STATE OF IDAHO
DEPARTMENT OF WATER RESOURCESAPPLICATION FOR PERMIT
To appropriate the public waters of the State of IdahoWATER RESOURCES
WESTERN REGION

RE: Application for Permit No. 57-12073

From: Kaiser, Anna
Sent: Monday, September 20, 2021 3:15 PM
To: jaquiso@sd365.us; jmclure@sd365.us
Subject: Permit Application Questions/Clarifications
Attachments: Application for Permit No. 57-12073.pdf

14. **MAP OF PROPOSED PROJECT REQUIRED** - Attach an 8½" x 11" map or maps clearly identifying the proposed point of diversion, place of use, section #, township & range. The map scale shall not be less than two (2) inches equal to one (1) mile.

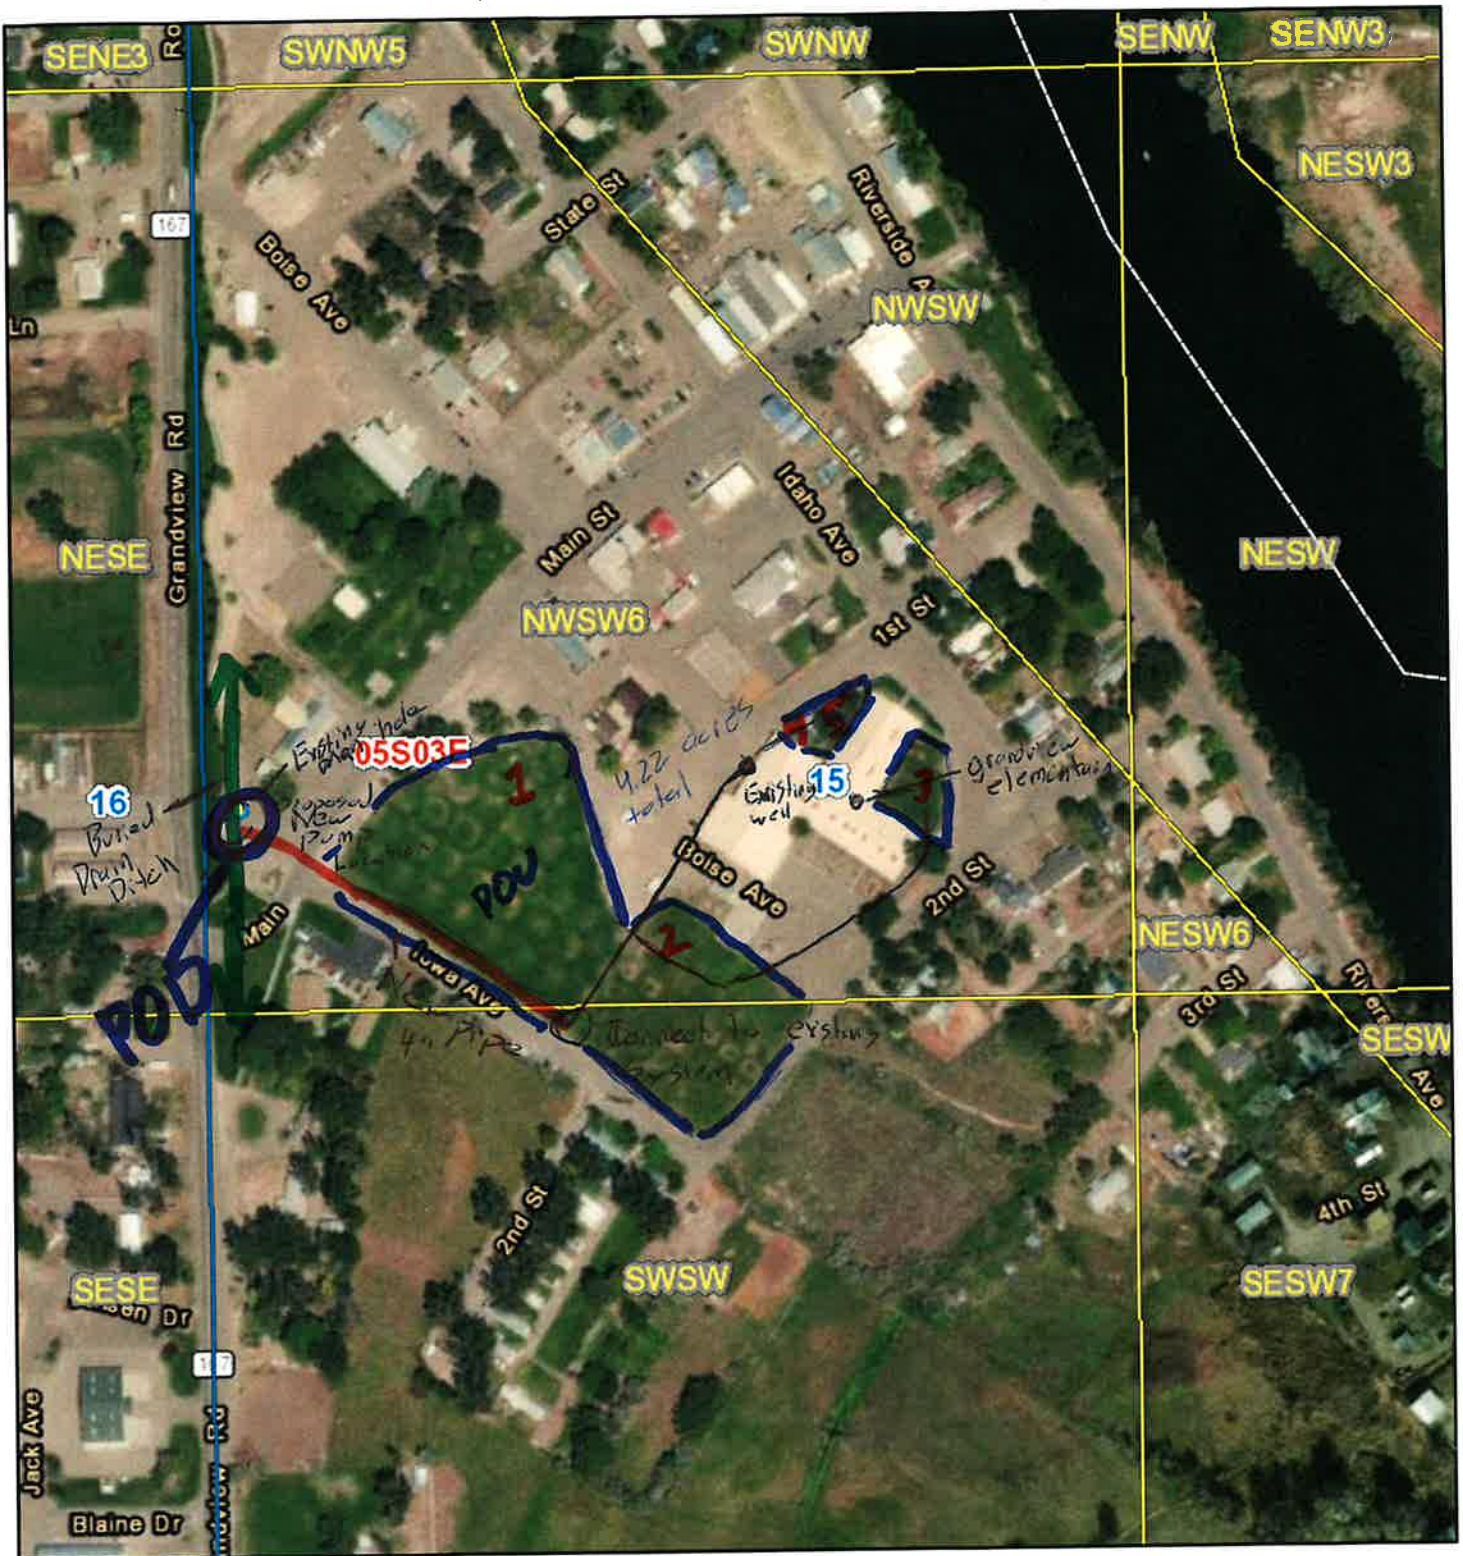
2. *Well*

- The map included with your application highlights a well.
- Do you intend to utilize the well as part of this water use proposal? If I am understanding this question correctly no, The amount requested does not include any utilization or support from the well. However, We are open to suggestions here. It's apparent now the well probably never should have been connected to the fields (yards 1&2) in the first place, I learned from your coworker (Alan?) as we turned in the application. We want to do what is A) Correct. And B) simple. The correct course of action (I think what I'm learning, you tell me) may be to isolate the well to only service the front small yards of the school as it was probably intended many years ago. The

- Item 3 on your application states you intended to draw water from a drainage ditch. Based on the Department's aerial imagery, it is unclear whether the drainage ditch consists of water from the Snake River or wastewater from the Grand View Irrigation District Canal.
- Please further clarify the source of your surface water.

2. Well

- The map included with your application highlights a well.
- Do you intend to utilize the well as part of this water use proposal?
 - If so, please add the well description to your application form (under items 3, 4, 7, and 12).
 - If not, you *may* need to file a separate application for permit describing the water use from the well.

The drain ditch was buried sometime after 2006, I've attached an aerial image from that time where the exposed canal can be seen. Later images it is buried and has grass along the road side on top of where it used to be. I've also included a photo of the man hole (POD) which if approved will be where we place our pump. In the photo you can see main street and the school in the background with the POD in the foreground. I first worked with the Canal company and they determined this does not come from the canal but is "surface runoff" or "shallow ground water" It does not come from the Snake River either but is flowing toward it.

simplest option would be to leave it alone and to plumb in with new water supply and they would both feed the irrigation system. I understand if that may not be possible. Ive attached a map trying to explain our set up and one trying to explain what we could do

with the well.
